Department of Energy
Washington, D.C. 20545

Docket No. 50-537
HQ:S:82:048

RESPONSES TO REQUEST FOR ADDITIONAL INFORMATION - QUESTION 110.78

Question 110.78

Figure Q110.78-IHX-1 General Arrangement of the IHX

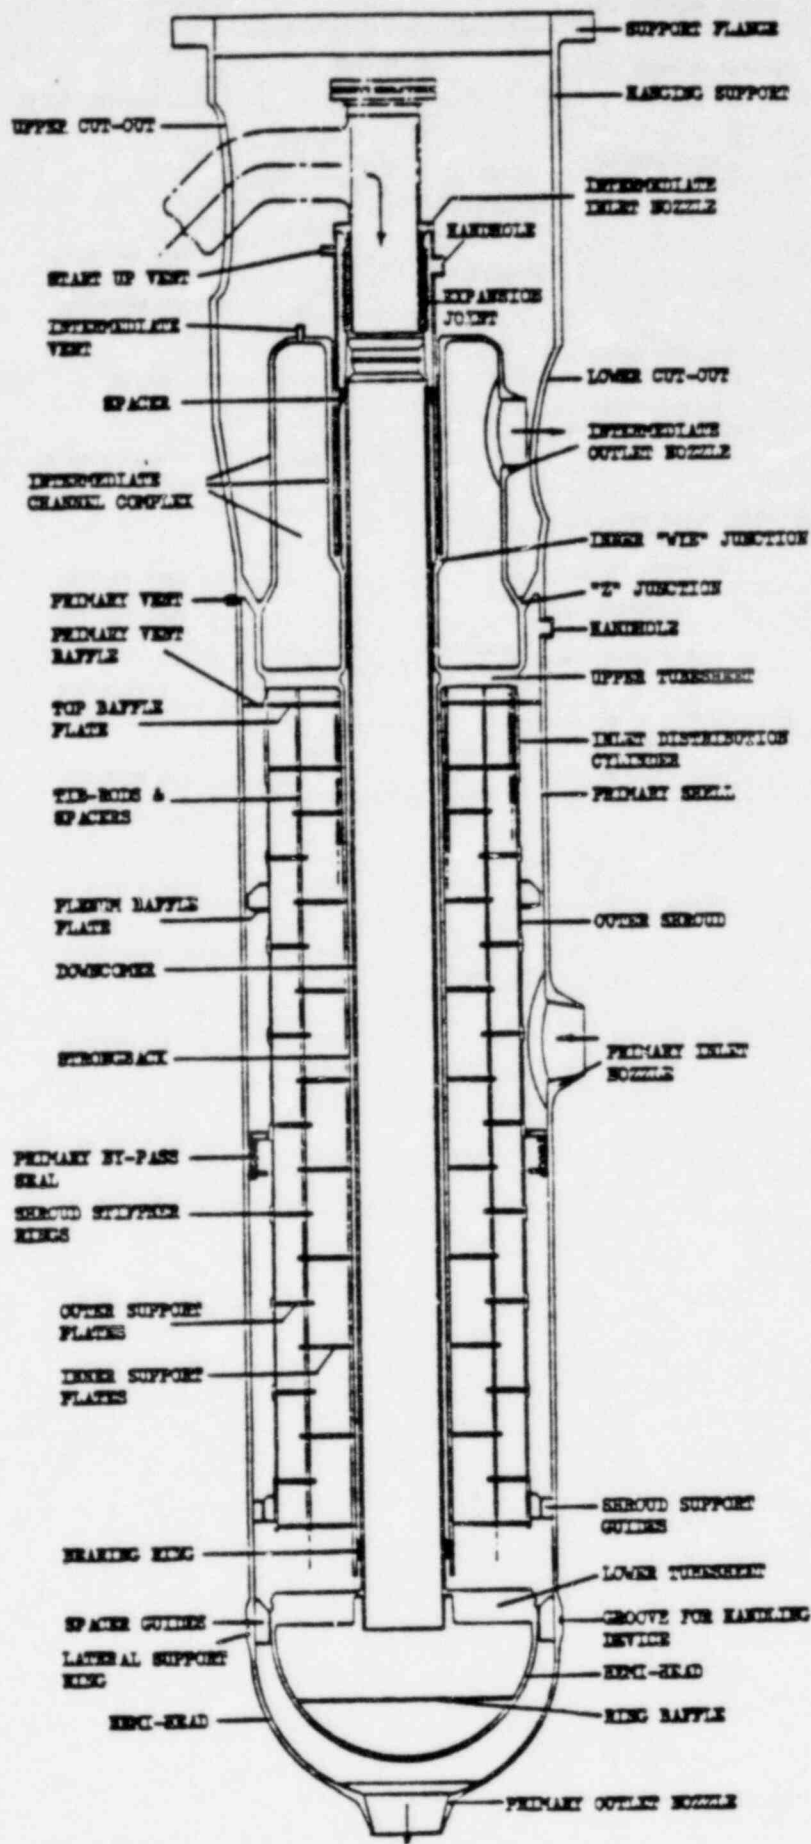
The response to Question 110.58 is unsatisfactory. The staff must be assured that the methods to be used in dynamic and static analysis to determine the structural and functional integrity of Seismic Category I components and supports are adequate. Of principal concern is the assurance that the analytical models will adequately represent the physical situations of concern, i.e., proper failure modes (static and creep-fatigue rupture, vibrational distortions, stability and deformations), adequate constitutive relationships (elastic, inelastic, viscoelastic, degradation with time), compatible boundary conditions, realistic component material properties.

The IHx provides the thermal link between the primary and intermediate heat transport piping. The IHx is a straight tube flexible downcomer design using an essentially counterflow arrangement of heated and cooled sodium. Figure 110.78-IHX-1 depicts the salient features of the IHx design. The main support for the IHx is the hanging support cylinder which is fabricated from type 304 stainless steel at the top and type 316 stainless steel at the bottom. It consists of a cylindrical shell that is welded to the IHx shell and tube bundle through a "Z" shape junction forging at the lower edge and has an upper flange which is anchored to the operating floor. The shell is fabricated from type 304 stainless steel in the bottom portions and type 316 stainless steel in the top areas where it is welded directly to the lower edge of the cylindrical hanging support through the "Z" junction. The bottom portion of the shell assembly consists of a lateral support ring with spacer guides to restrain the tube bundle, the lower tubesheet, the hemispherical head, and the primary outlet nozzle. The tube bundle is comprised of two major sub-assemblies: (1) the bundle, consisting of tubesheets, tubes, support plates, tie rods and spacers, outer shroud, hemi-head, downcomer, strongback and by-pass seal, and (2) the channel assembly consisting of replaceable bellows, upper head, intermediate outlet nozzle, intermediate vent, inner and outer channel cylinders, upper downcomer pipes and the "Z" forging. The uppermost portion of the channel contains a removable IHx bellows assembly. The bellows permits the differential axial thermal growth between the downcomer and straight tubes and also serves as a portion of the pressure boundary between the primary and intermediate systems. A detailed description of the IHx is included in Chapter 5 of the PSAR.
